**Re: Response to Peer Review Comments
Bentinck Gravel Pit
382063 Concession 4 NDR
West Grey, Ontario
VCL File: 123-0064**

On behalf of the Municipality of West Grey, WSP Canada Inc. (WSP) has completed a peer review of our Noise Impact Study, dated August 17, 2023, prepared in support of the proposed Bentinck Gravel Pit. The peer review comments are outlined in WSP's letter dated May 27, 2025. Responses to the peer review comments are provided herein.

FIGURE 1: FOLIAGE AREAS

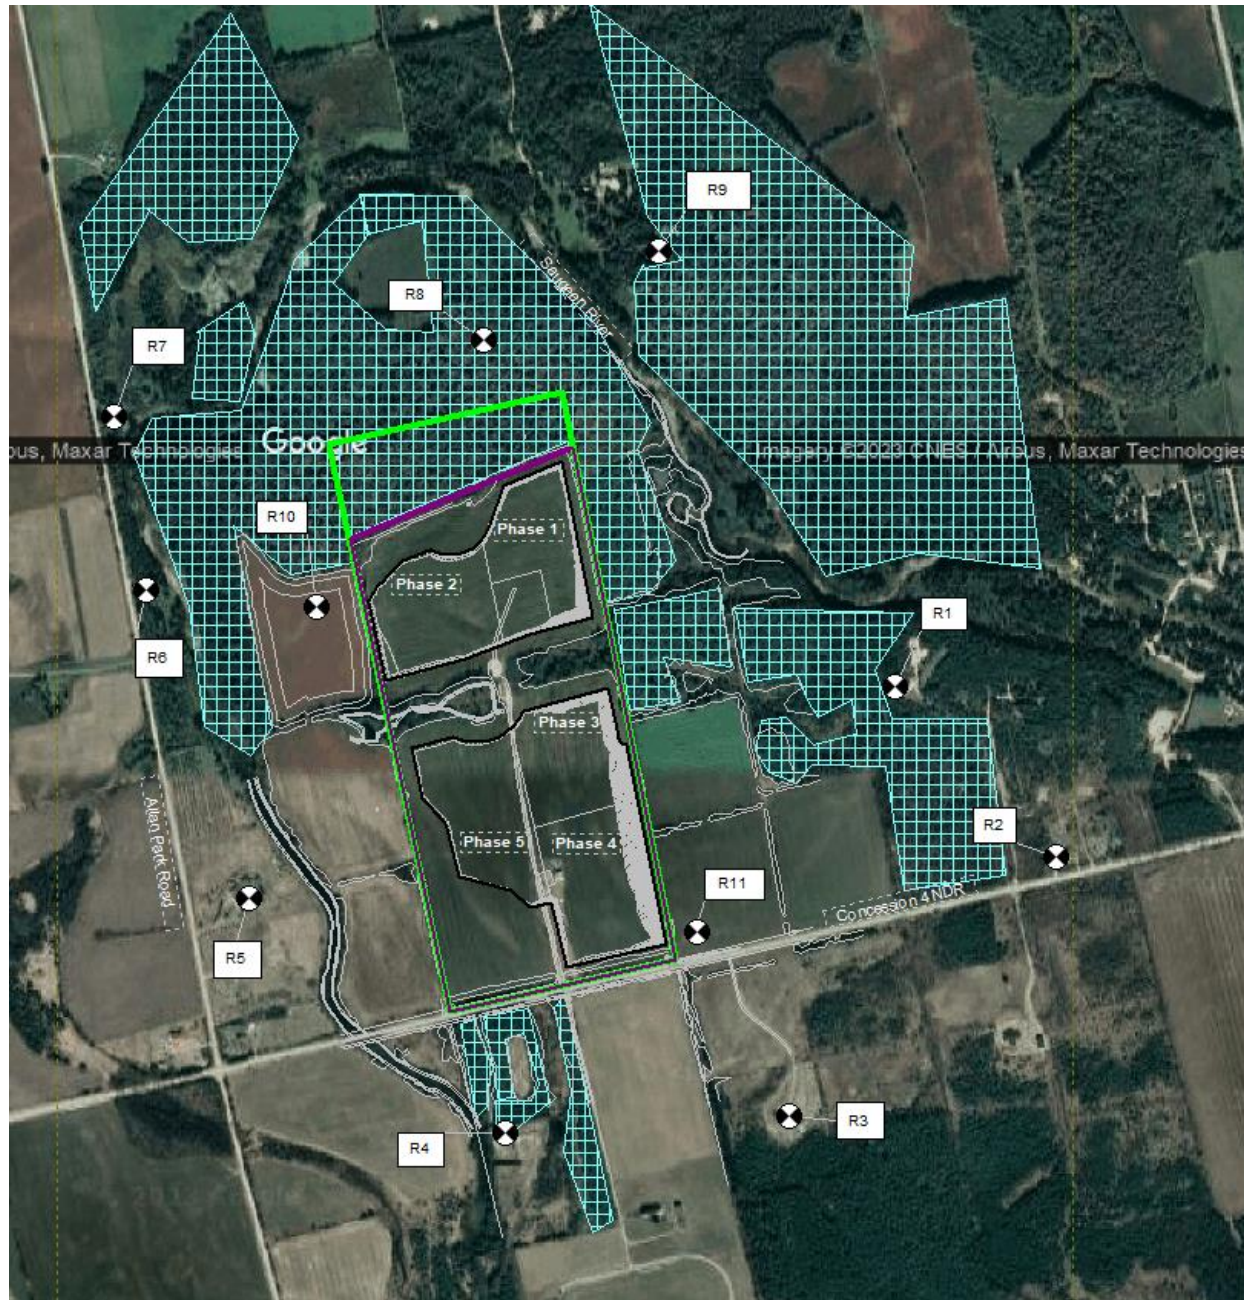
34. *The NIS mentions that it used the CadnaA feature “foilage” for existing woodlots at a height of 12 m. WSP notes this was not shown in any figure which woodlots this feature was used for. WSP also notes that in past discussions with the MECP noise review engineers regarding the use of the foliage feature in CadnaA, that this feature needs to be used with caution. It should only be used if the consultant can confirm the noise model represents the actual expected performance of the predictable worst case conditions (i.e. when foliage is minimized). Please provide a map illustrating the extent of the woodlots considered. Please provide technical justification for the height of 12 m, location and size of the woodlot and for using the foliage feature in CadnaA to be representative of conditions that could occur throughout the year.*

A figure showing the woodlots used in the assessment is included as Appendix B. The light blue hatched areas are the woodlots that the feature was used for. Also included in the Appendix is a ground level photo from Concession 4NDR towards R4 to provide some context regarding the woodlots.

The dense woodlots were observed to be a combination of deciduous and coniferous trees of adequate density such that there would be no view of the receptors through the woodlots even during the winter season. As per ISO 9613-2, trees and shrubs provide sound attenuation if they completely block the view along the sound propagation path. Mature trees vary in height (oak 50 to 70 feet, maple 40 to 60 feet, pine 70 to 100 feet and fir 70 to 200 feet). A conservative height of 12 m or about 40 feet was used for the woodlots.
